DRB Memorandum

Project Location: Post Office Square, Acton, MA

Third Review of Project

Date of DRB Review: 02.20.2014

FENCE
HEIGHTS.
DRB
2.21.14

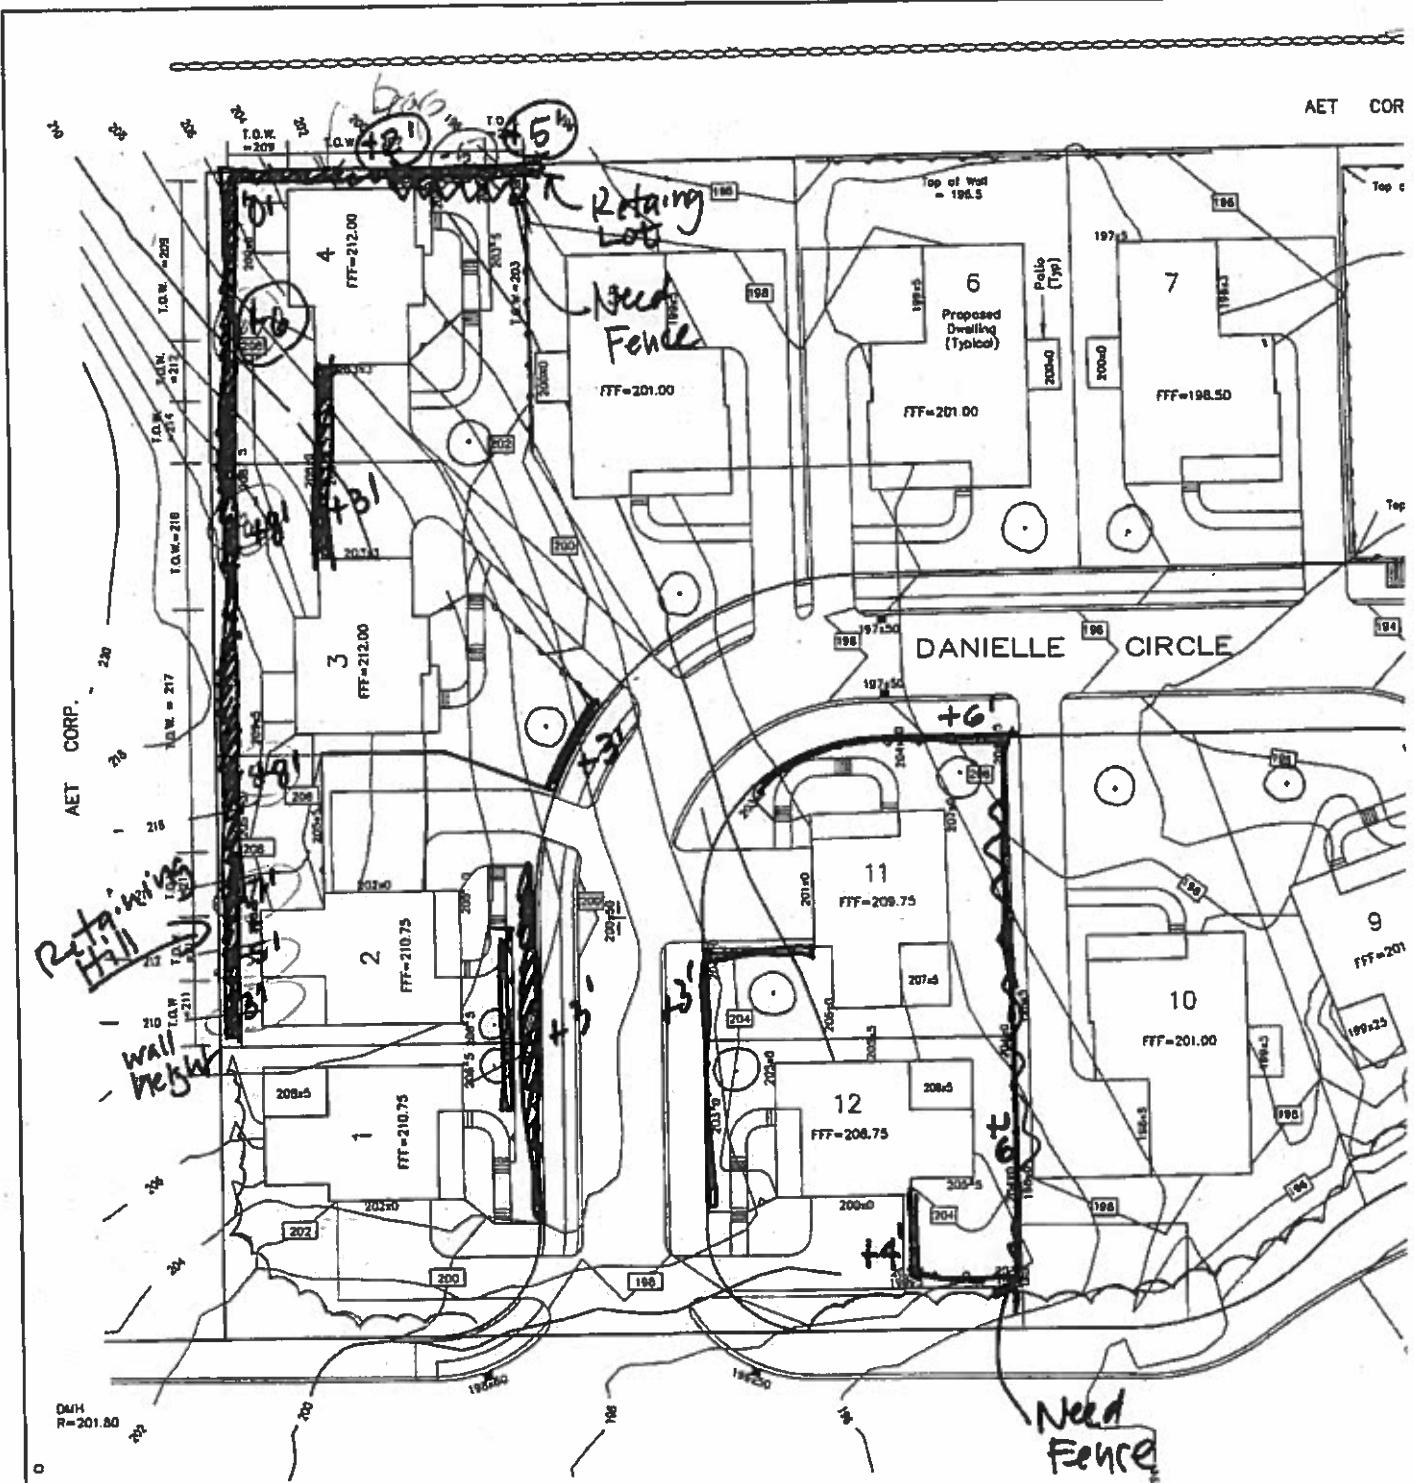
- *DRB suggested switching units 9 and 10 so that a bank of higher buildings can be created, consolidating the amount of walls needed.* N/A.
- *In situations where retaining wall are over 3' in height, the engineer suggested the wall be terraced, using two wall of lower heights. Railings would not be needed along the tops of wall and the overall visual impact of the wall would be softer.* Walls are now terraced at units 1 & 2. Most of the other walls along the street seem to be at around a maximum 3' height except at units 10, 11, & 12 where the wall height is 6' (see enclosed diagram).

- *Along the north side of the site, the retaining wall at the property line is in some locations, 8 feet in height. The architect suggested one solution to reduce the height of the walls would be to use a unit with a front facing garage thereby allowing the back of the homes to be built into the existing slope and significantly reducing the amount of excavation and retaining wall required. The garage faces would be attractive - partially concealed with a balcony above and detailing.* The developer did not originally consider front facing garages because he assumed front facing garages were frowned upon in Acton. The sentiment of the Board was that while the previous state is true, making the home fit best with the topography of the site is a higher priority. Danielle Singleton will forward images of these building styles to the DRB. Walls have been terraced at this area, the lower wall is at a 3' height, the upper wall (close to the property line) ranges from 3' to 8' height.

- *We discussed whether the septic field would need a fence along the top of the retaining wall, since the wall reaches a height of almost 8' on the south end. If the septic field will be open for people to use (which the DRB recommends), then the board recommends a fence be added. No fence is shown on the Planting Plan.*

In general the DRB supports this project, and believe it has an appropriate scale and density for the site and location. The DRB would encourage additional reductions in wall heights where ever possible, and recommend attractive fencing along tops of walls with more than a 2'-6" drop in locations where pedestrians will be walking or playing at the top of the wall.
